MEMORANDUM

To: Design Review Board
From: Tony Leavitt, Associate Planner
Date: May 9, 2013
File No.: DRV12-01513
Subject: **324 CENTRAL WAY MIXED USE PROJECT DESIGN RESPONSE CONFERENCE (CONTINUED FROM APRIL 15, 2013)**

Design Response Conference #2

DESIGN RESPONSE ITEM #5: GARAGE DOOR DETAIL

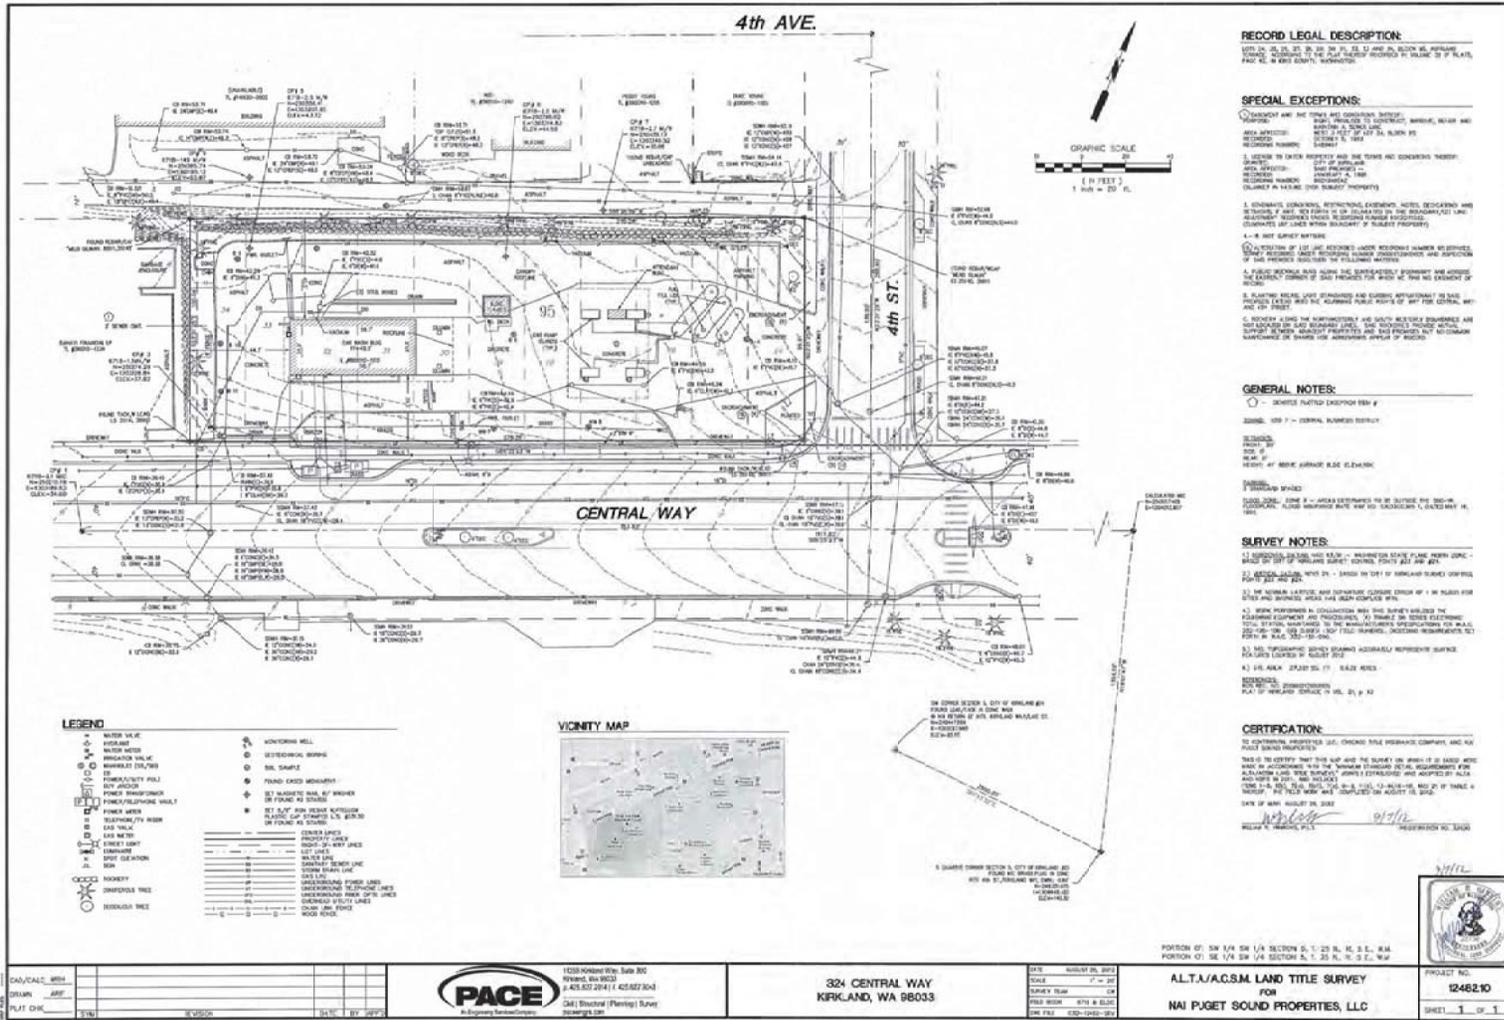
The Board requested that the applicant incorporate additional colors or materials to break up the perceived monochromatic color scheme. Additionally the applicant was asked to provide more details about the proposed parking structure garage door.

The garage door location will require additional review through the permitting stage. Public Works will likely have queuing concerns and Planning will need to review accessibility of required retail parking. It is likely that the area will be an opening and the door will be internal to the garage to separate retail and residential parking.

The applicant has incorporated a new dark bronze accent color (see Attachment 2, Sheet A3) and provided details for the garage door (see Attachment 2, Sheet A6).

FLOOR PLAN: LEVEL L2

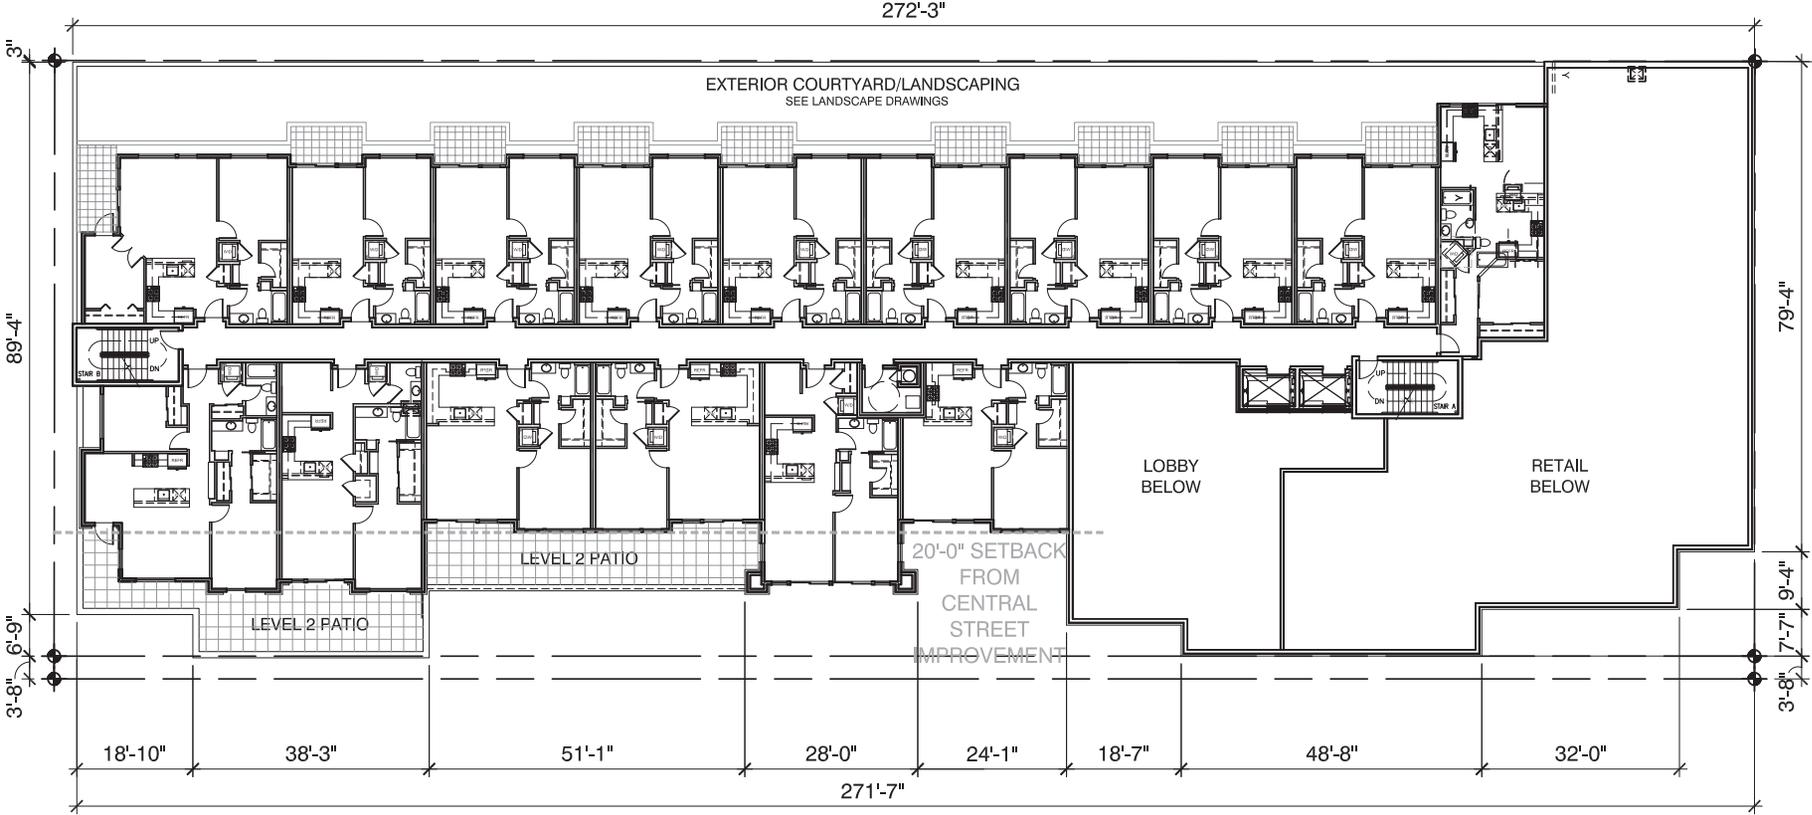
- 10 foot encroachments on the Levels L2 thru L5 (see Attachment 2, Sheets A18 thru A20) along Central Way and 5 foot encroachments along 4th Street.
- Average 15' setback along both Central Way and 17.5' along 4th Street.
- Approximately 4,527 square feet of total setback encroachment. A majority of this encroachment square footage occurs along the Central Way setback.
